Product Change Notification / SYST-10ZGXL795

ERRATA - AVR128DA28/32/48/64 Silicon Errata and Data Sheet Clarification

AVR128DA Silicon Errata and Data Sheet Clarification

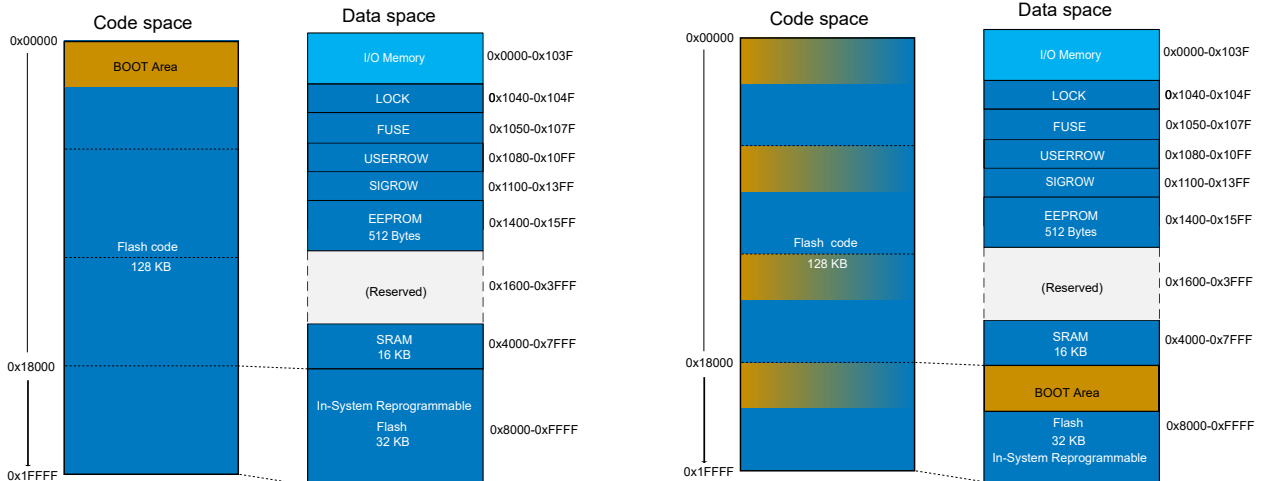
The inter-section Flash protection mechanism does not take into account the FLMAP bit field when checking if the address is in BOOT, APPCODE or APPDATA areas. It uses for comparison only the address offset between Flash start address in data space (0x8000) and the accessed address. This will cause the mirroring of the BOOT area in each Flash section selected by FLMAP (in blocks of 32 KB). Refer to the image below.

For read operations, the FLMAP bits work as documented when the Boot Read Protect (BOOTRP) bit is not enabled. For write operations, the inter-section Flash protection works properly only when FLMAP is set to '0x00'.

Use only store program memory (SPM) instructions to write and load program memory (LPM) instructions to read Flash memory.

Figure 3-1. Reset System Overview

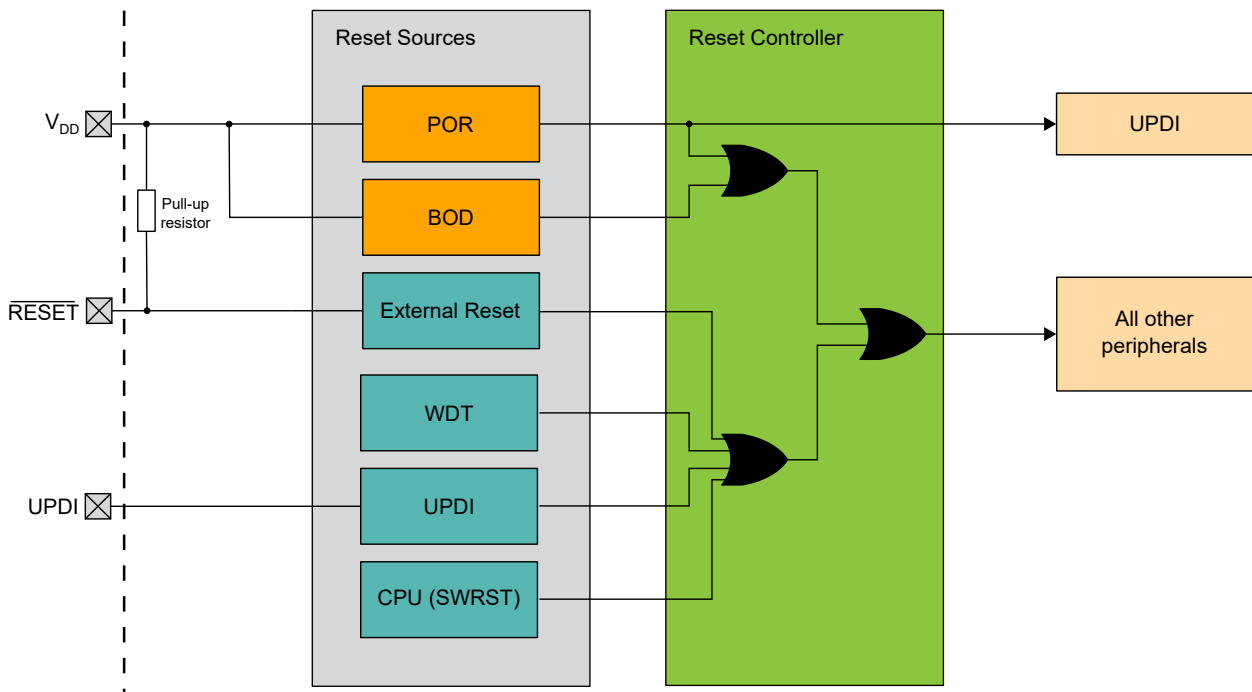
A clarification has been made to add the missing block diagram figure.
